City of Portland, Maine - Building or Use Permit Application

Permit No: 10-1335	Issue Date:	CBL: 112 F022001
-----------------------	-------------	---------------------

Past Use: Commercial / Medical Office	Proposed Use: Commercial / Medical Office: Install natural gas RTU on the roof.	Permit Fee: \$110.00	Cost of Work: \$8,250.00	CEO District: 1
		FIRE DEPT: <input checked="" type="checkbox"/> Approved <input type="checkbox"/> Denied * See Conditions	INSPECTION: Use Group: B Type: HVAC DMC-2003

Jeanie Bourke - RE: Baxter Blvd RTU structural assessment

SSK6

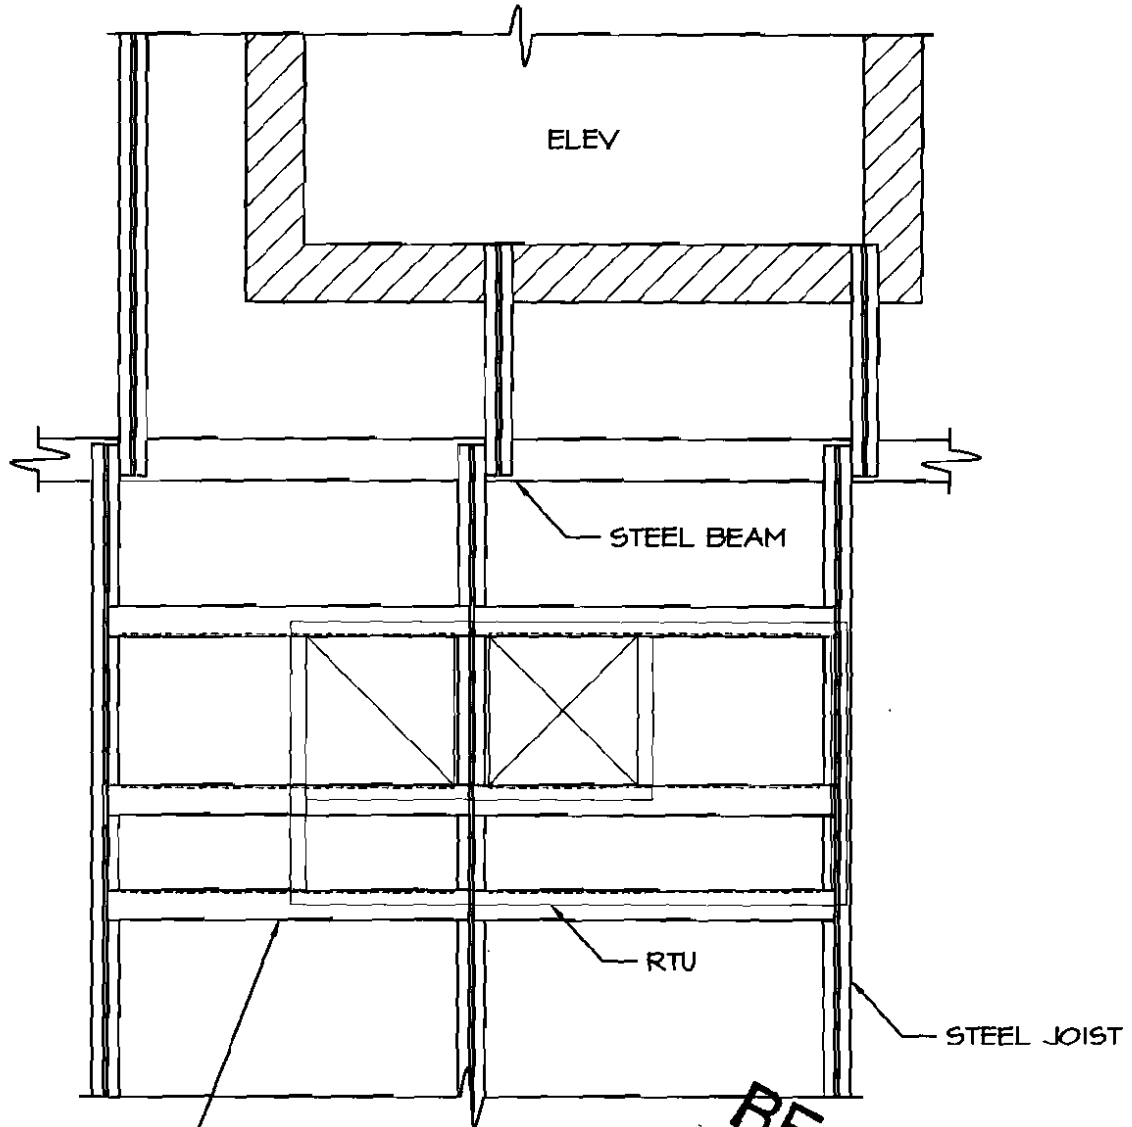
Hi Peter,
I am reviewing this permit and Rancor directed me to you for structural questions.
Thanks

The City of Portland is asking for structural information regarding the new RTU we have set in place. I would like to pass on your contact information to the City to coordinate this information. We have submitted our documentation for the HVAC permit, however they are requiring a structural review / design document.

Attached is the detail on the frame that we installed to support the new RTU.

L4x4x3/8
COPE VERT LEG
BEAR HORIZ LEG ON
STEEL JOIST
(6 TYPICAL)

ADD WEB L 1 1/8 x 1 1/8 x 1/8 TO BOTH SIDES OF STEEL JOIST FROM TOP CHORD AT RTU SUPPORT L TO NEAREST BOTTOM PANEL POINT WHERE RTU SUPPORT ANGLE BEARS FURTHER THAN 6" FROM TOP PANEL POINT. SEE SSK3 FOR SIMILAR WEB MEMBER.

SSK3

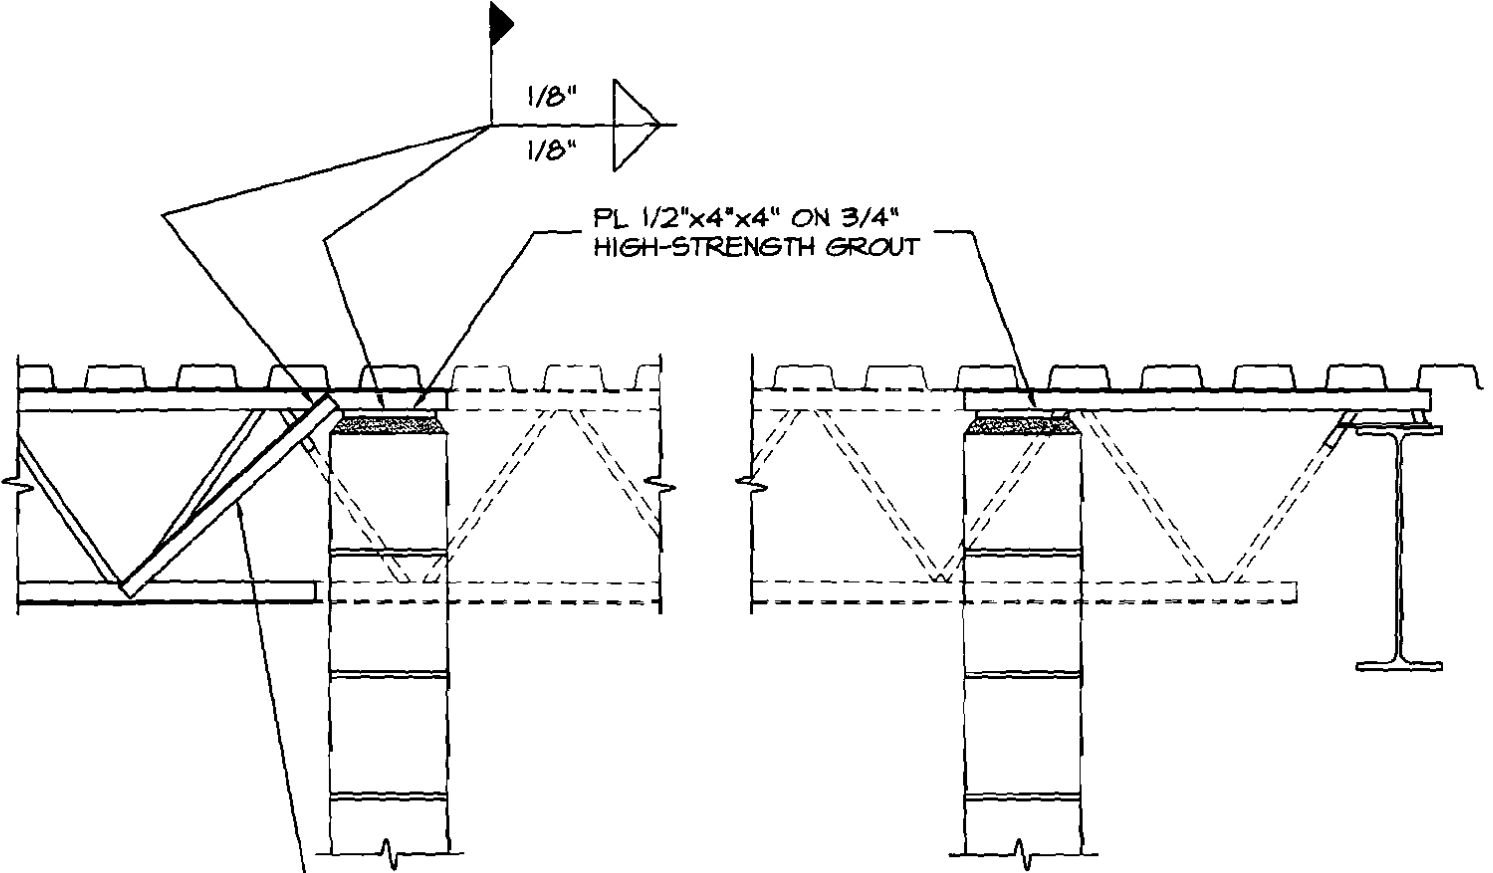
Comments:	City of Portland
10/25/2010-gg: Received permit application by mail. Ranor Inc. Owes \$10.00 also will send me the gas#. /gg	
11/5/2010-jmb: Routed from Tammy with review notes	
11/9/2010-jmb: Left msg with Brian at Rancor via admn., with question on roof structure loading.	
11/23/2010-jmb: Called Rancor, Brian, he is out until 11/29, spoke to Corene, she will send an email to him.	
11/30/2010-jmb: Received a structural SK from Peter H., emailed him for the referenced SK3. Received

PL 1/2"x4"x4" ON 3/4"
HIGH-STRENGTH GROUT

ADD L 1/8 x 1/8 x 1/8
BOTH SIDES FROM BEARING TO
CLOSEST BOTTOM PANEL POINT
